PRELIMINARY DRAINAGE REPORT

CROSSROADS MIXED USE EL PASO COUNTY, COLORADO

FEBRUARY 2021

Project #18-003A
PCD Filing No.: SP-20-011

Design Point 12

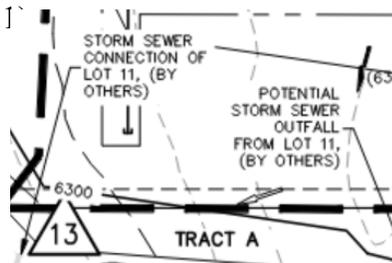
Delete duplicate

DUPLICATE DELETED

DETENTION BASIN OUTLET STRUCTURE DESIGN

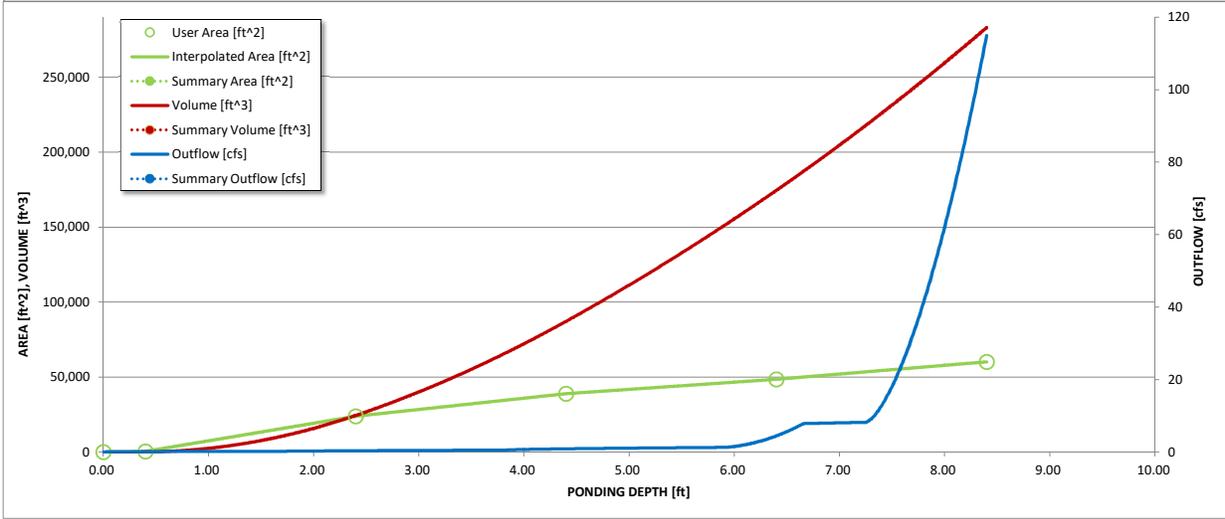
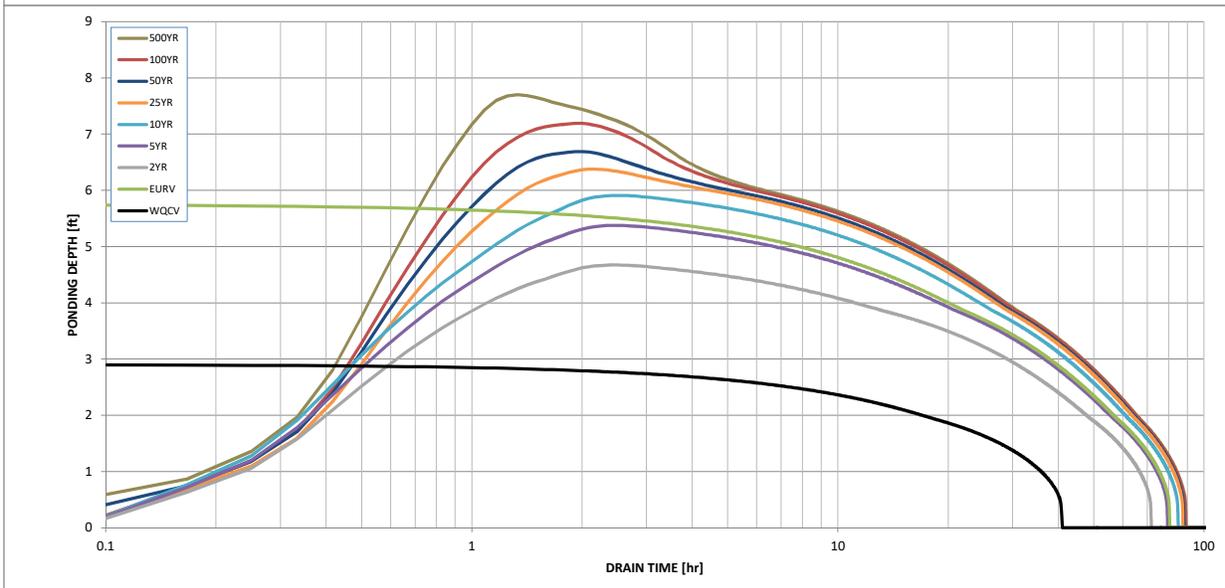
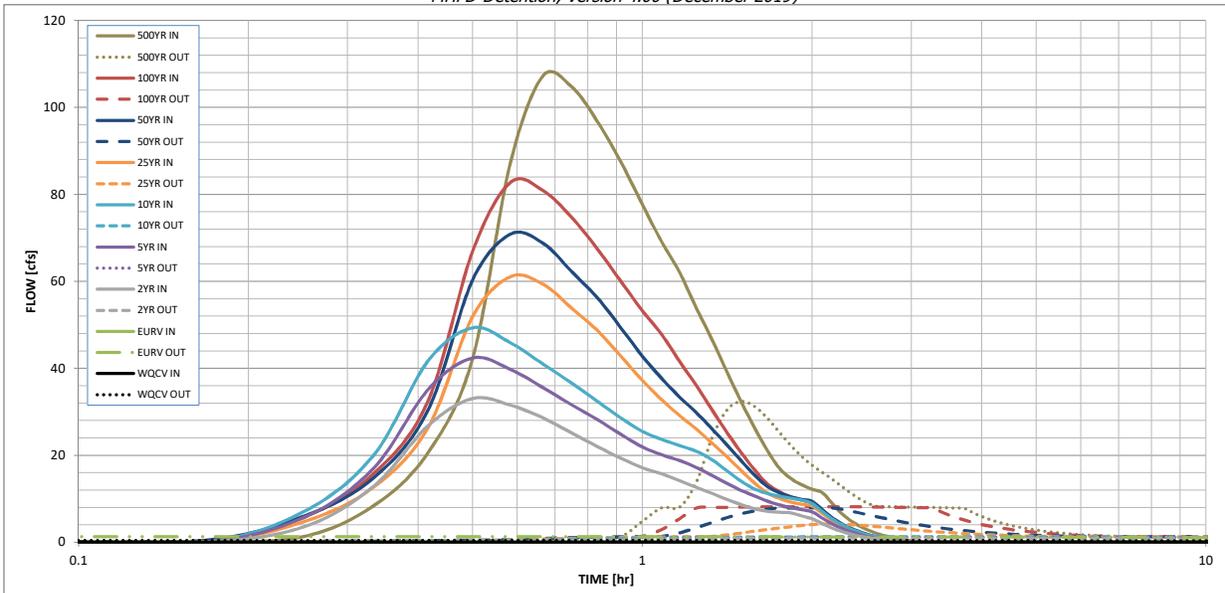
Revise. Must be at or below predevelopment. Unresolved.

DARIN DISCUSSION WITH GILBERT LAFORCE;
 MOST EFFICIENT SOLUTION OBTAINED

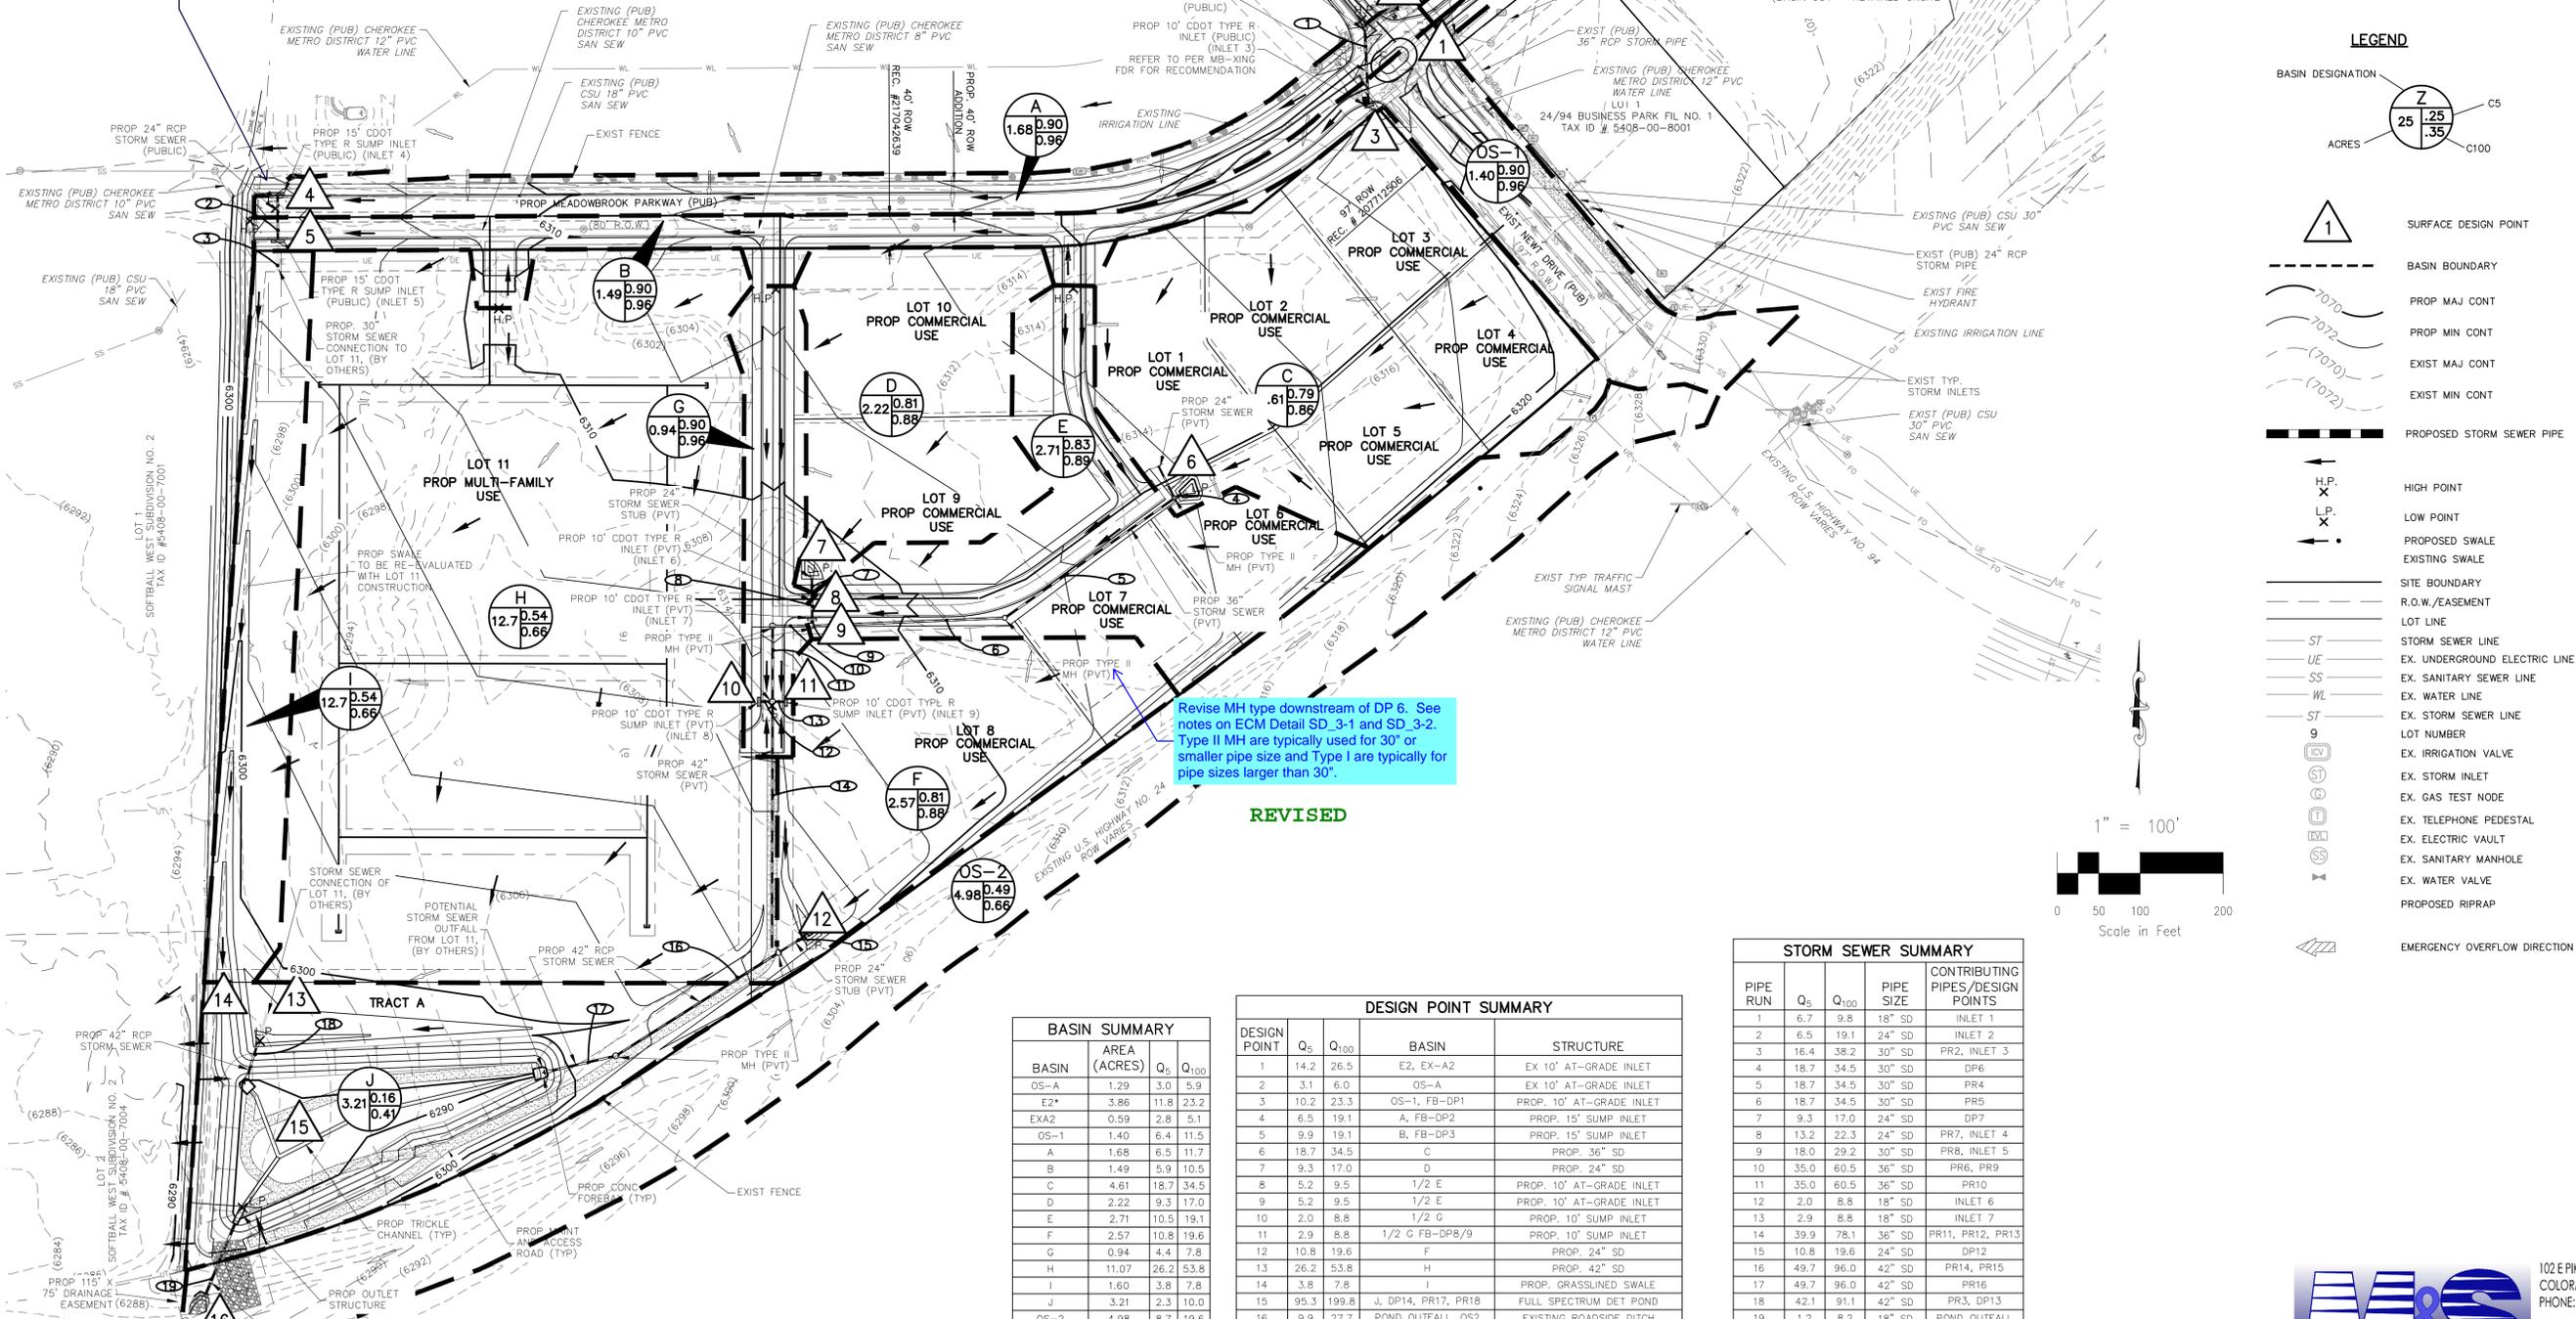
update to match the preliminary site plan that shows a temporary cul-de-sac and update the narrative. Unresolved. See comments on the preliminary plan.

CUL DE SAC UPDATED

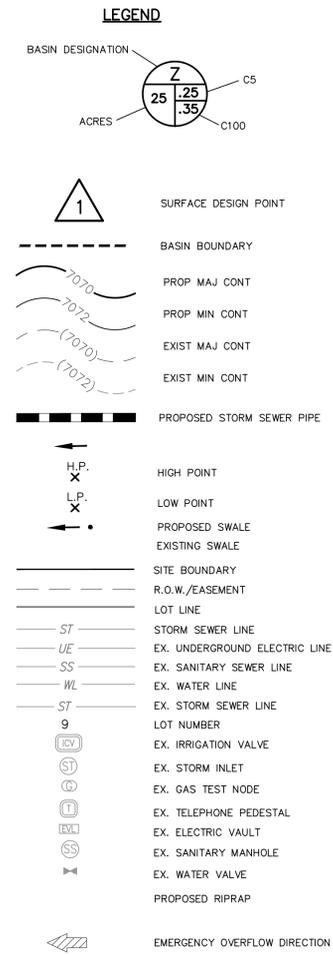
Revise MH type downstream of DP 6. See notes on ECM Detail SD_3-1 and SD_3-2. Type II MH are typically used for 30" or smaller pipe size and Type I are typically for pipe sizes larger than 30".

REVISED
